**NORTHFIELD TOWNSHIP PLANNING COMMISSION
NOTICE OF REGULAR MEETING
June 3, 2015 at 7:00 p.m.
Second Floor, Public Safety Building
8350 Main Street, Whitmore Lake, MI 48189**

Site Plan Review For Northfield Township, Michigan

Regarding: **O'Donnell Electric**
Site Plan Review No. 2
OHM Job No. 0151-15-1031

Regarding: **O'Donnell Electric**
Site Plan Review No. 3
OHM Job No. 0151-15-1031

NEE JOB NO. 1160 SHEET NO. C1

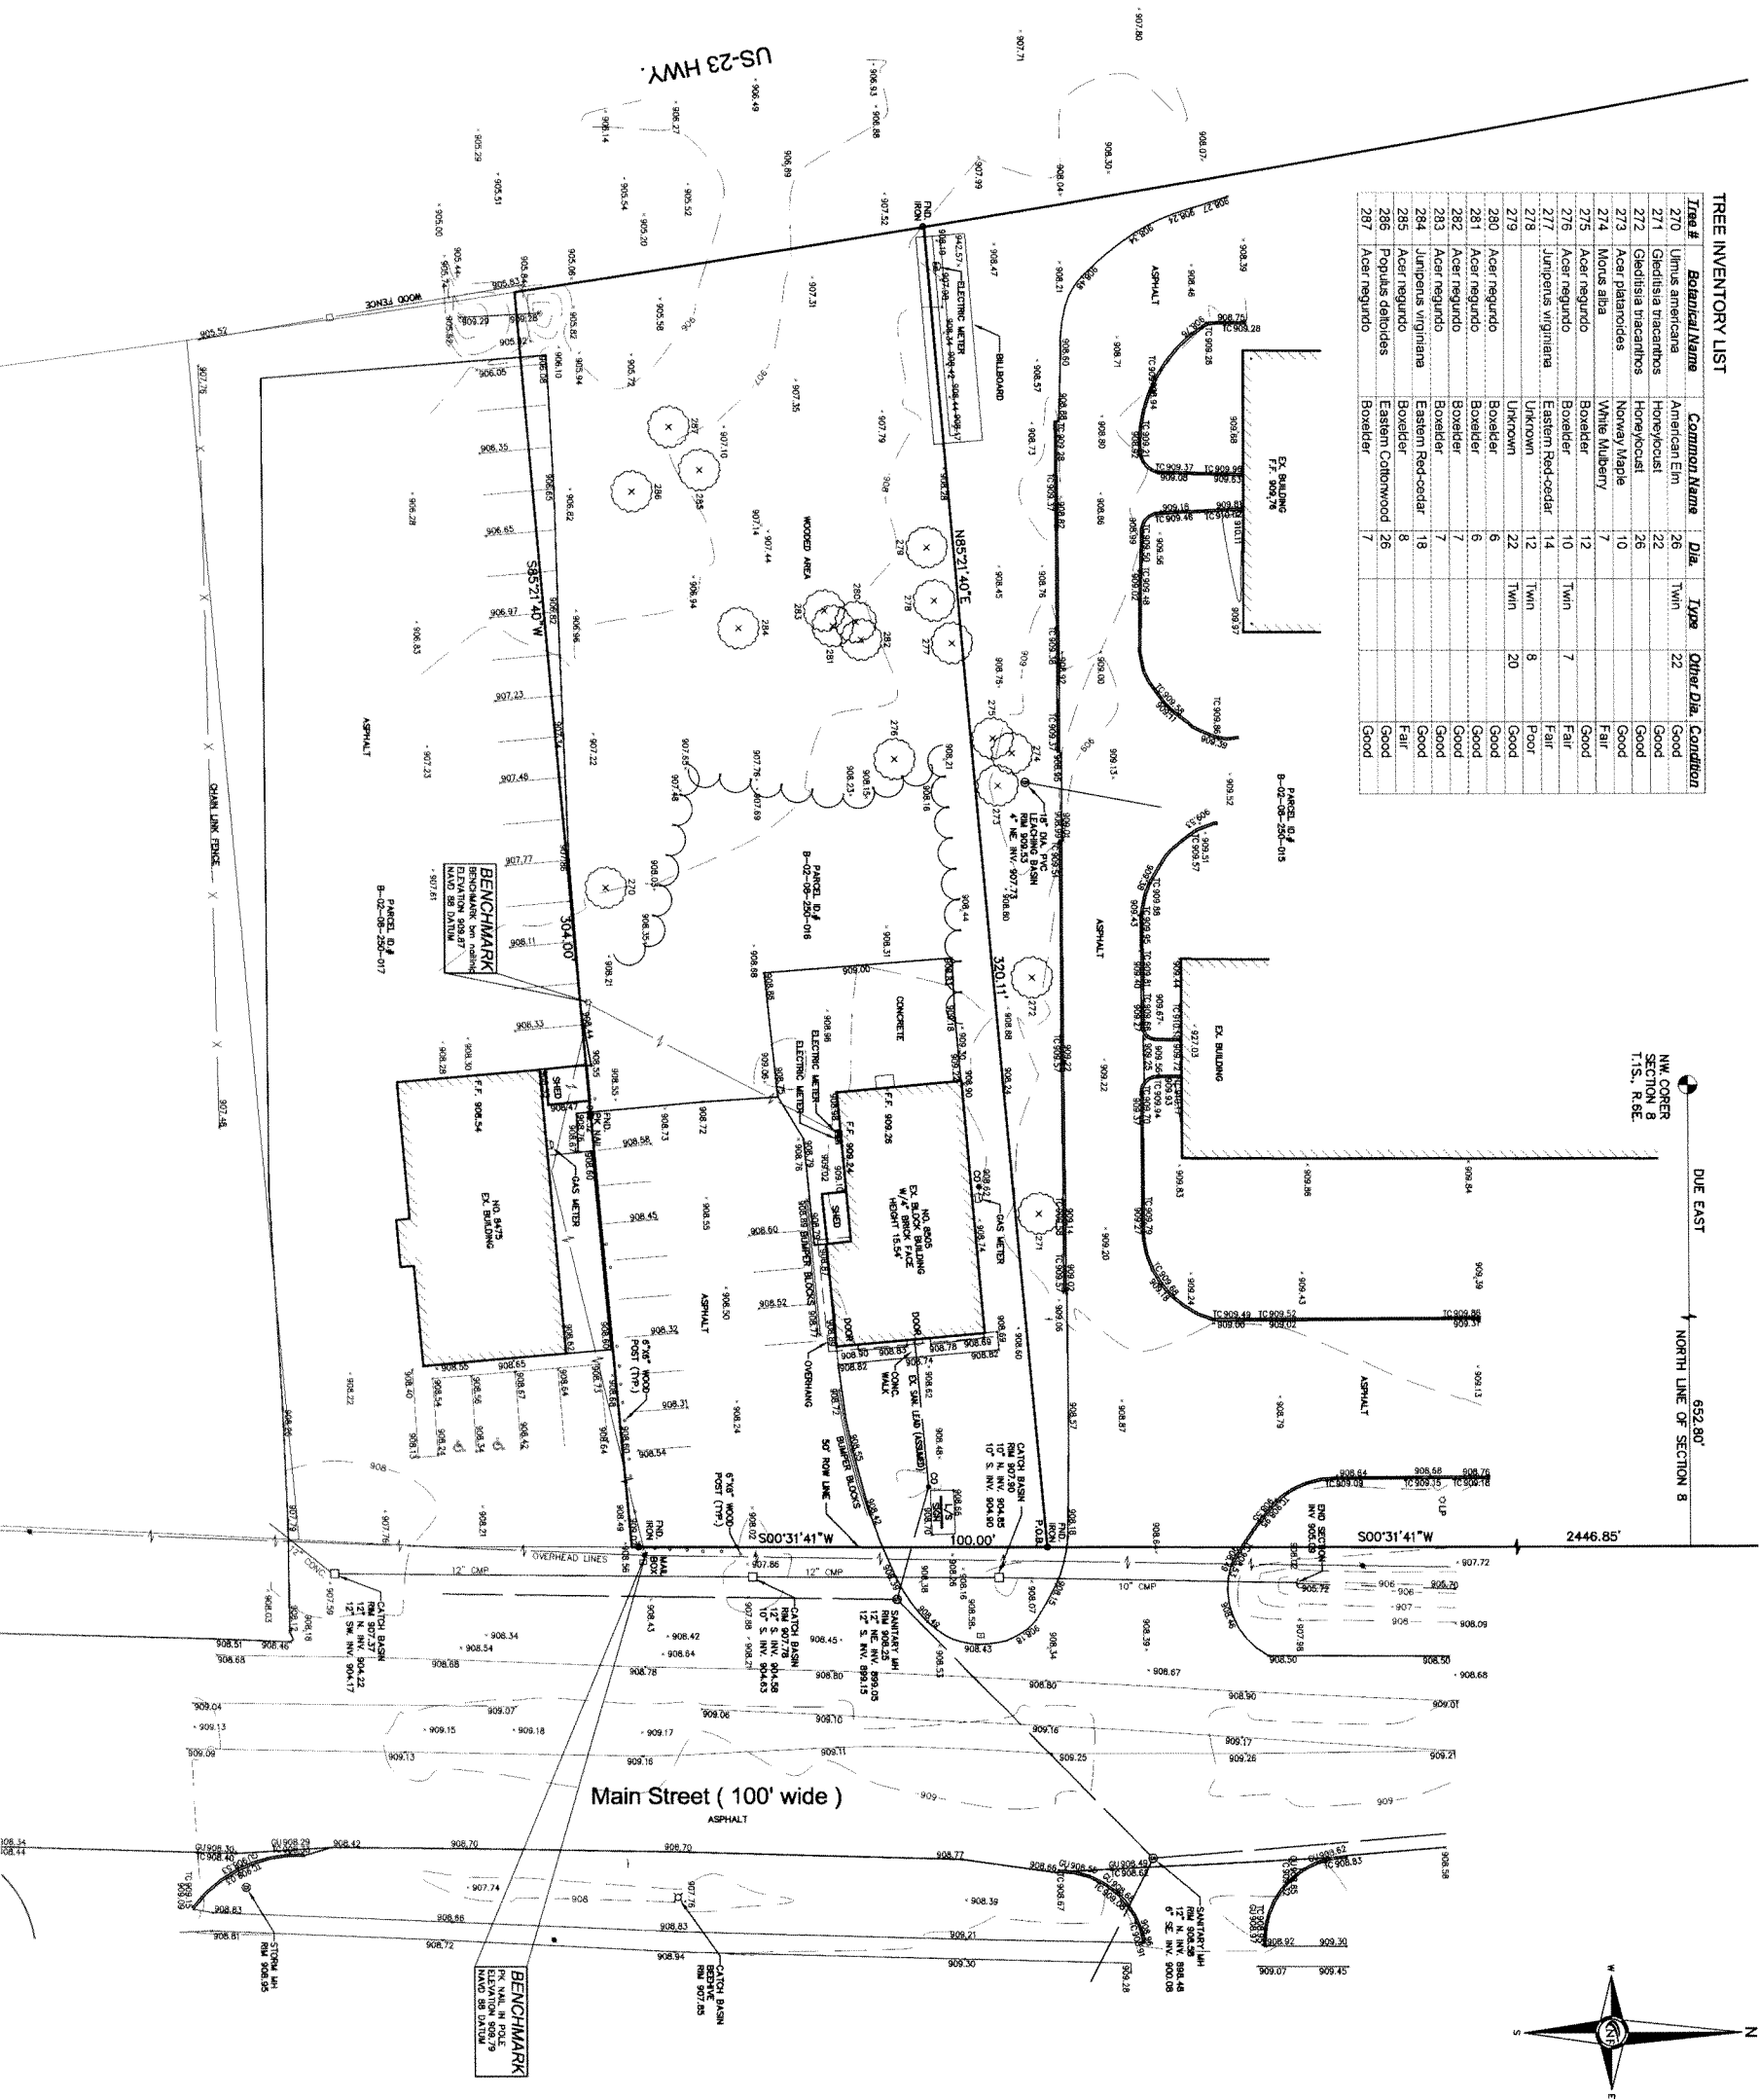
As provided on Sheet C2, ten (10) trees will be removed to accommodate the proposed storage structure totaling 42.8 inches of DbH to be removed. Replacement trees (Sheet L902) total 46.5 inches of DbH meeting the standards of Section 36-723(f)(3)(b).

SHEET NO.:
C5

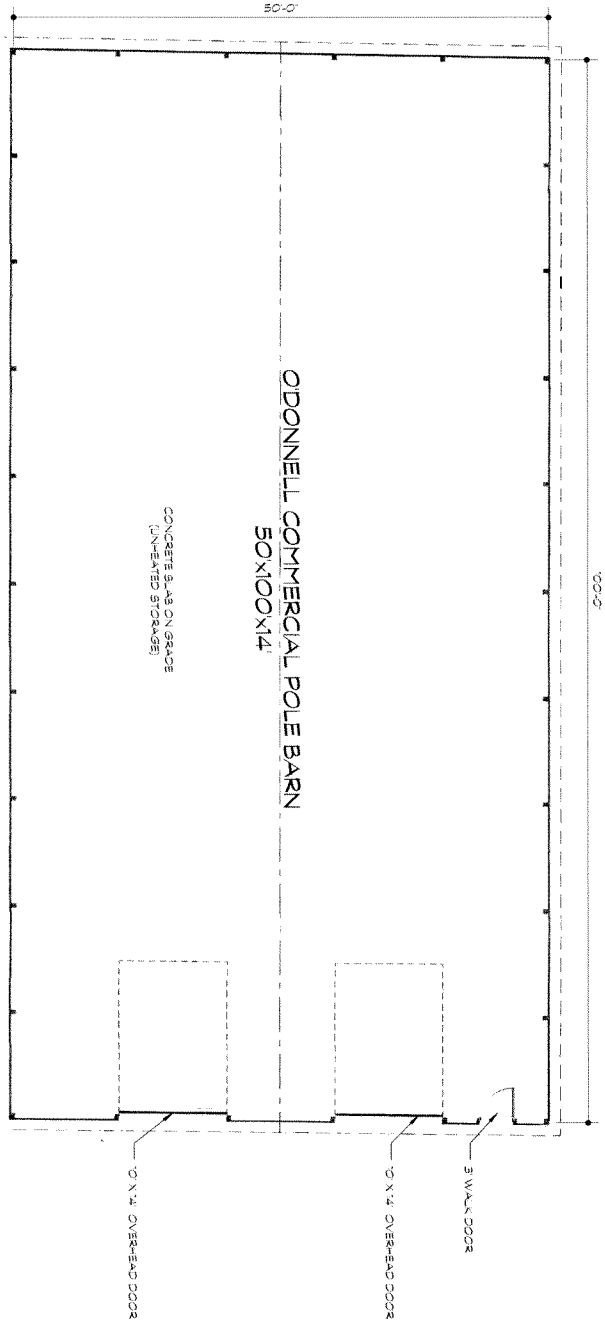
1. A stormwater narrative shall be provided to clarify the design and intent of the site stormwater management and conveyance system.
2. A drainage area map showing the extents of any runoff onto property shall be shown on the plans.

2. A drainage area map showing the extents of any runoff onto property shall be shown on the plans.

A drainage area map was inadvertently not included as part of the site plan submittal and was to be included as part of the engineering submittal. The drainage area map has been included as part of this submittal.

CONCEPT FLOOR PLAN - POLE BARN

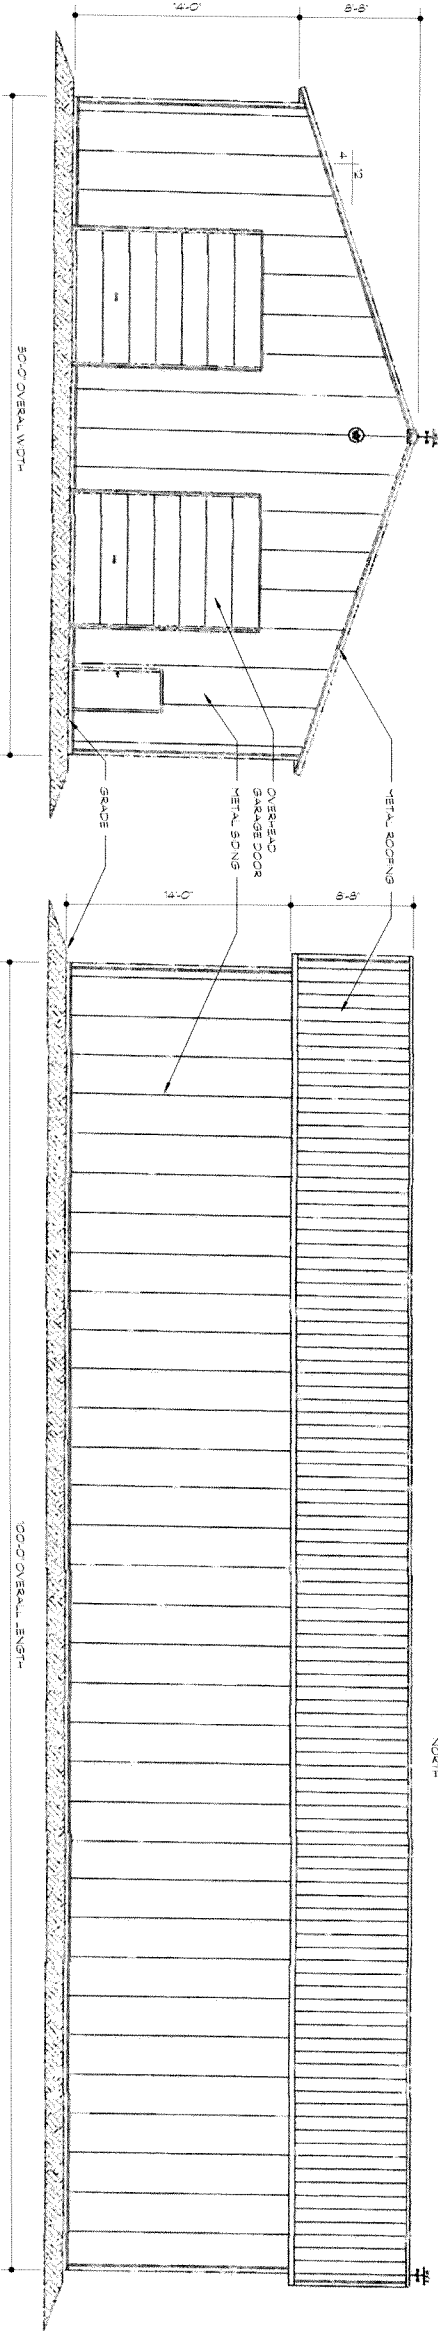
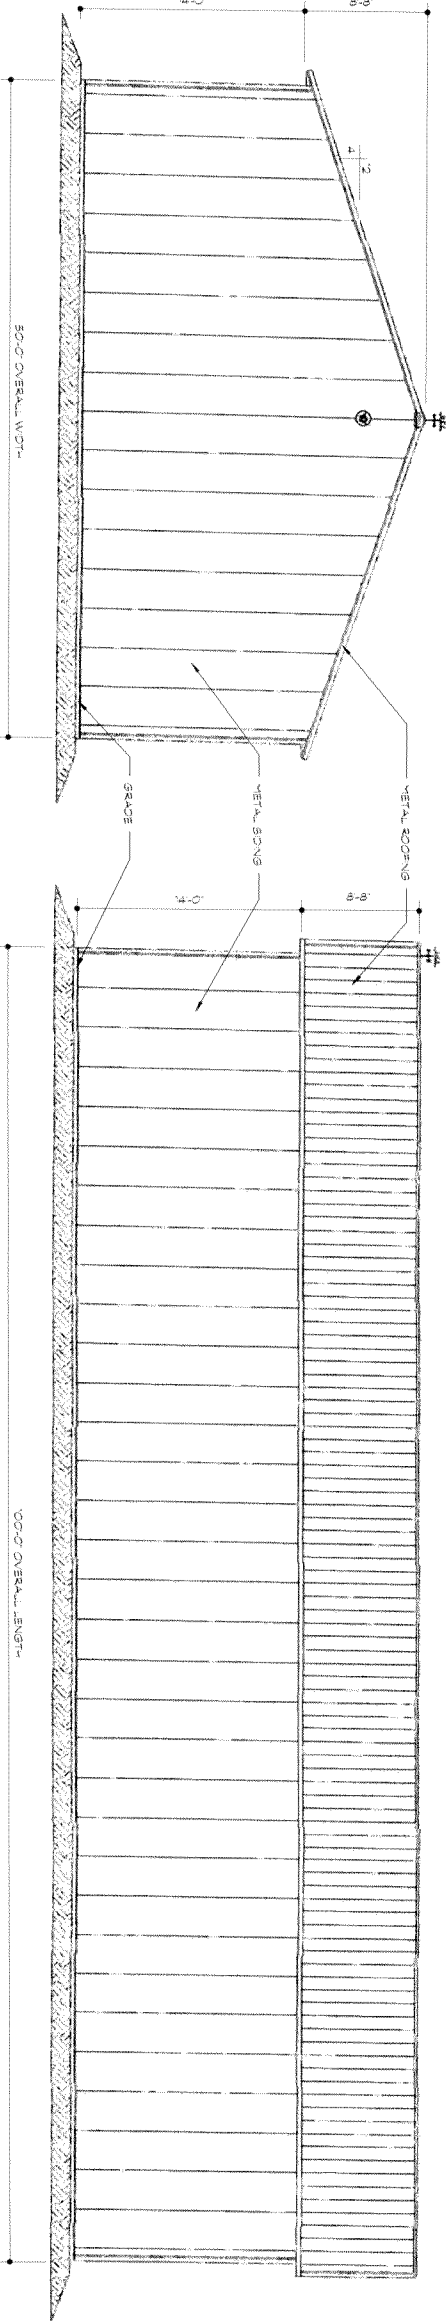
Floor plans and elevations have been provided in the plan set. The proposed storage barn will have an open floor plan and the exterior materials include metal siding and roofing.

Items to be Addressed: *Provide floor plans and building elevations.*

E.P.101

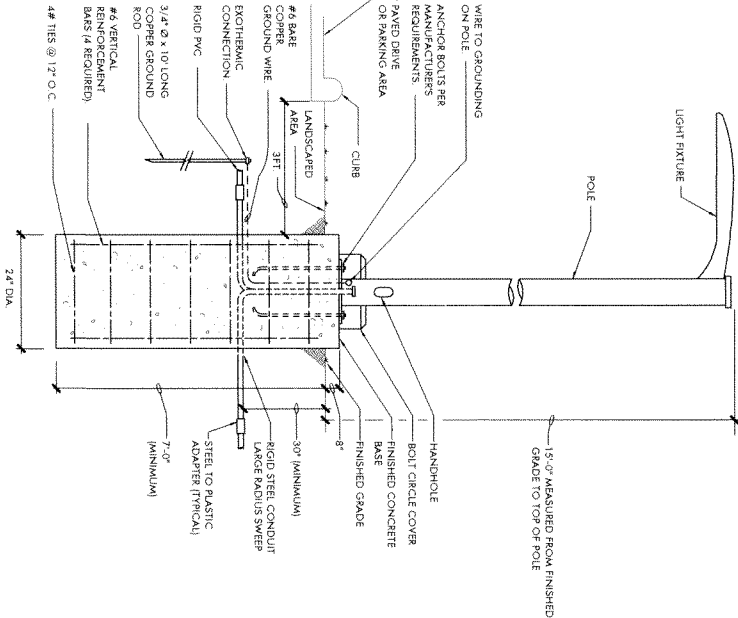
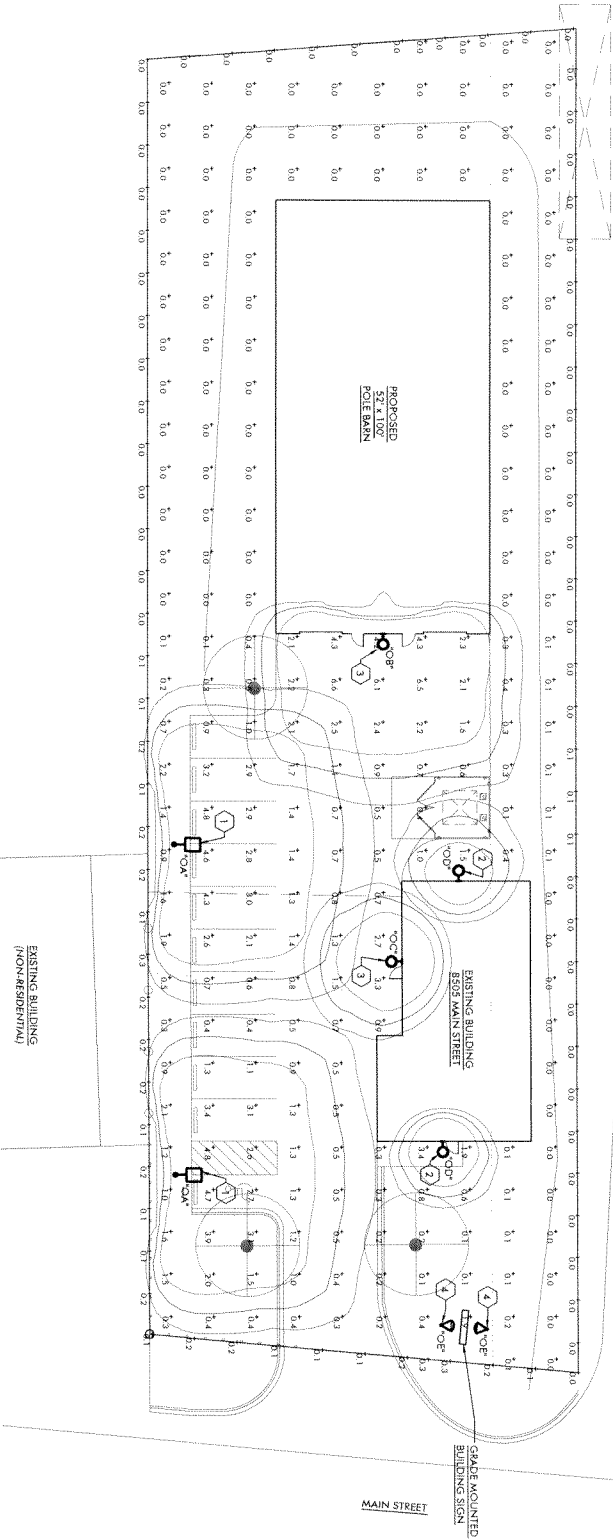
Sheet E.P.101 of the plan set indicates two (2) new pole-mounted fixtures (15 feet in height), four (4) building-mounted fixtures, and two (2) flood-light fixtures (for existing sign). For sites with less than 100 parking spaces a maximum fixture height of 16 feet is permitted.

As provided, illumination levels are appropriate. Initially, we were concerned, with the flood lighting proposed for the existing sign. However, the applicant has noted the flood light fixture includes four-side shields to control the light emitted from the fixture in order to provide compliance with the requirements of Section 36-728.
